DRAWN S HOLMES	DATE 24-7-85	MATERIAL	TITLE	DRAWING NO
CHK'D <i>pd</i>	SCALE	FINISH	CIRCUIT DIAGRAM	1627
FILE	TOL		VX-150

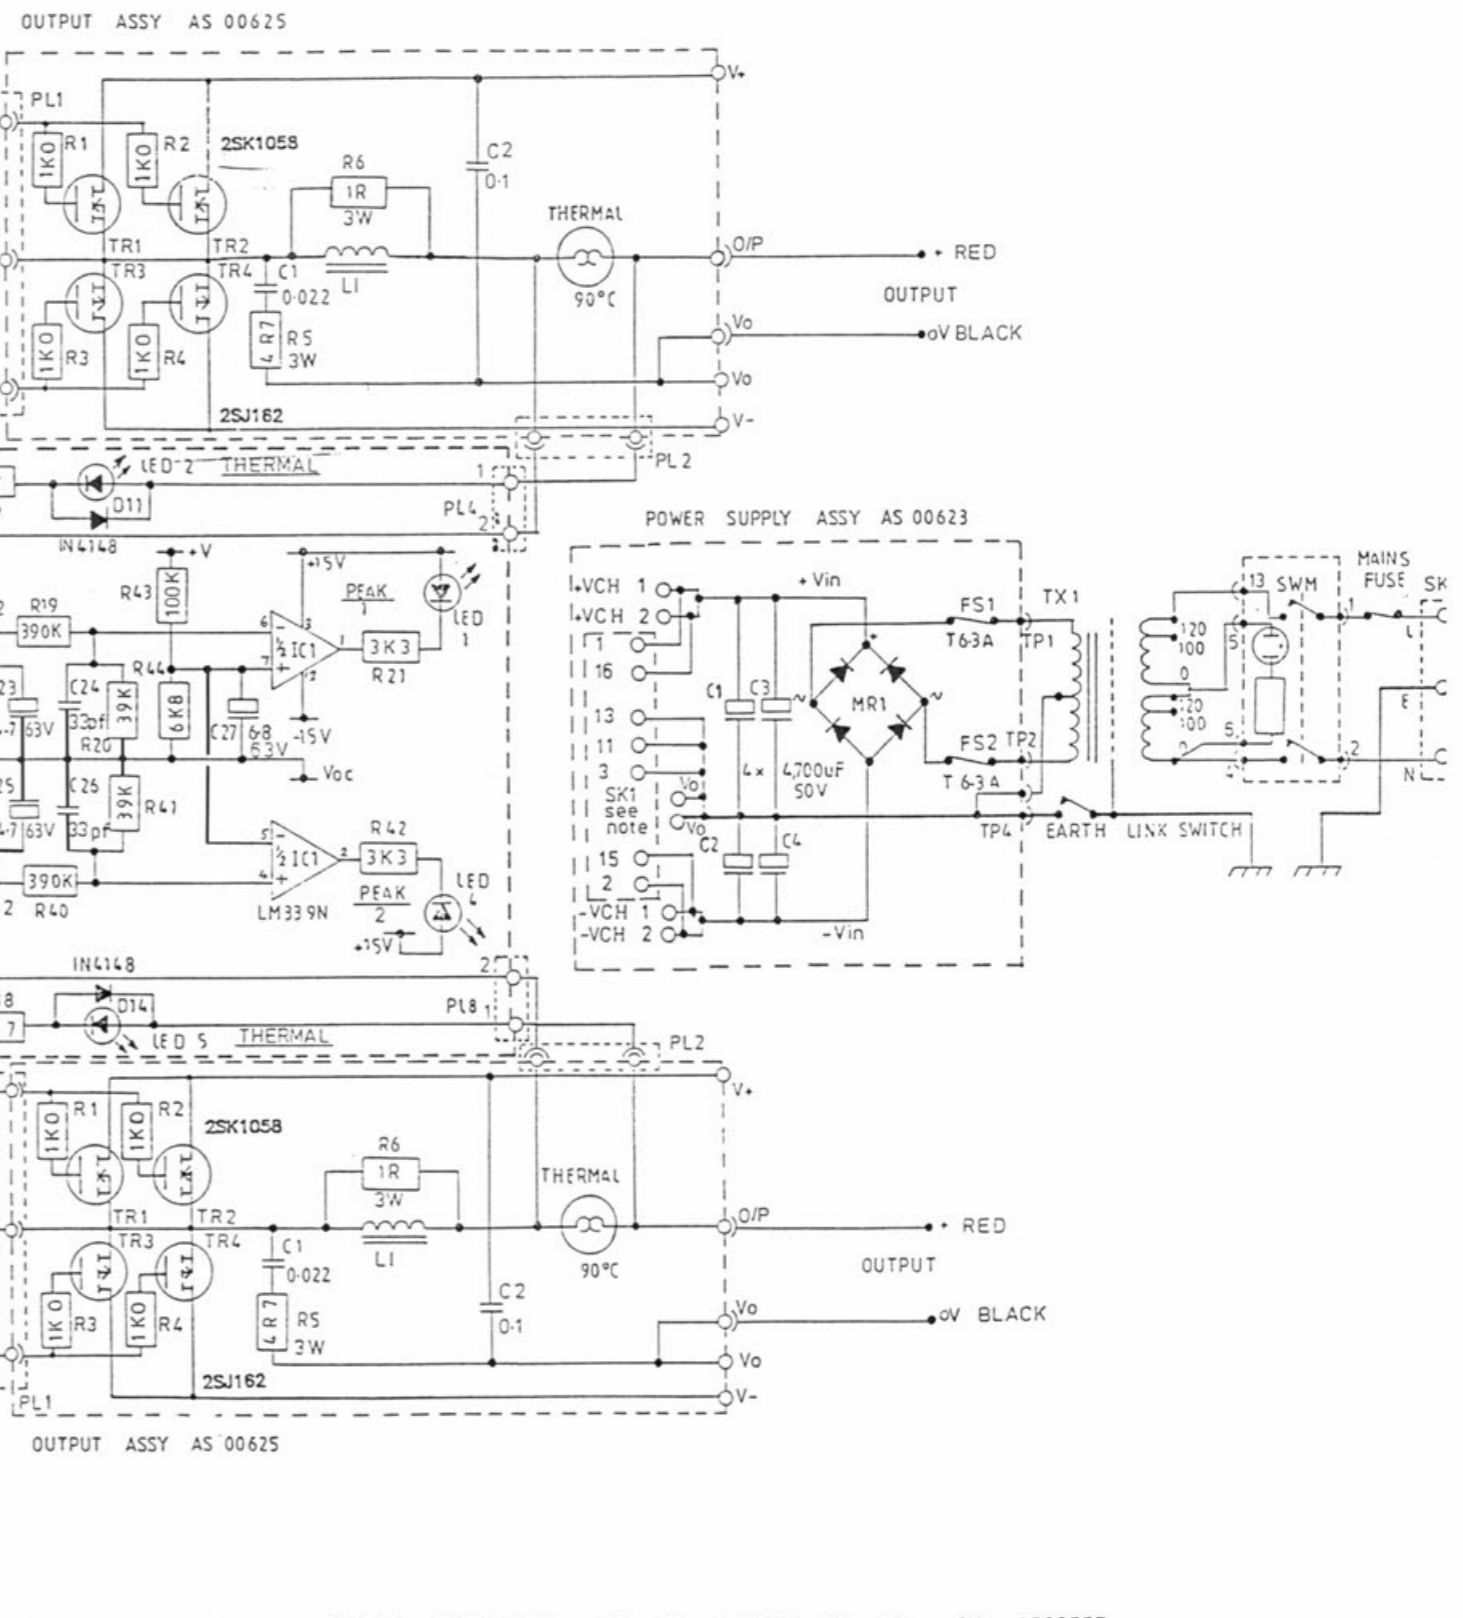
① HF BANDWIDTH RESTRICTION MUST BE APPLIED TO THE INPUT MODULE (NOT TO THE MAIN DRIVER AS INSTABILITY MAY OCCUR)
 C4 & C10 MAY BE INCREASED TO (100pF → 70kHz 220pF → 35kHz)
 HF COMMON MODE REJECTION WILL NOT BE AS GOOD BUT THIS SHOULD NOT BE A SERIOUS PROBLEM.
 ② THE EARTH LINKS TO CHECK ON ARE LK1 & LK2 ON THE INPUT PCB.

ISSUE 4	ISSUE 3	ISSUE 2	ISSUE 1
	AMENDED TO ACCOMMODATE REVISION POSITION OF C31 & C32 C11-0115	SEE CHANGE NOTE H0091	R11&R32 were 22K R45 was 33K C31&C32 added PL1 & 2 added to AS 00625 22.5K → 22K
